TRAFFIC NOTES AND SPECIAL CONDITIONS

- 5.As work progresses, location of temporary traffic control devices will be adjusted and modified, as necessary by the contractor at contractor's expense.

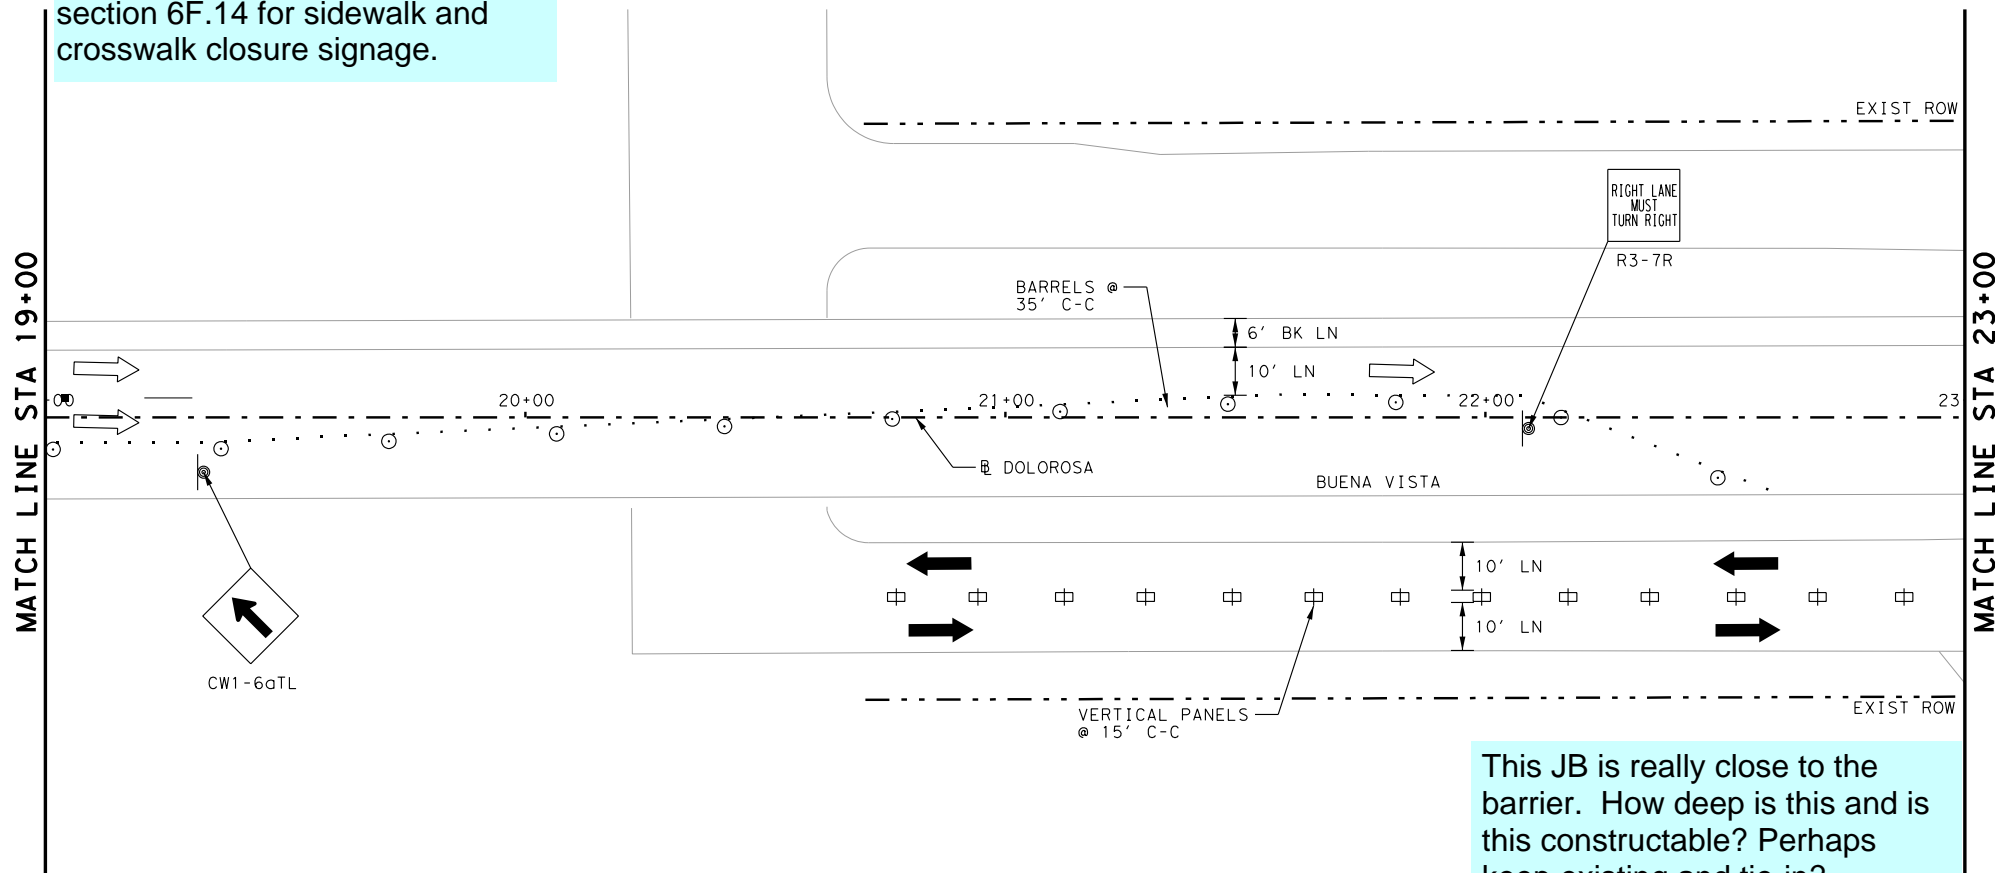
General Comment: Review section 6F.14 for sidewalk and crosswalk closure signage.
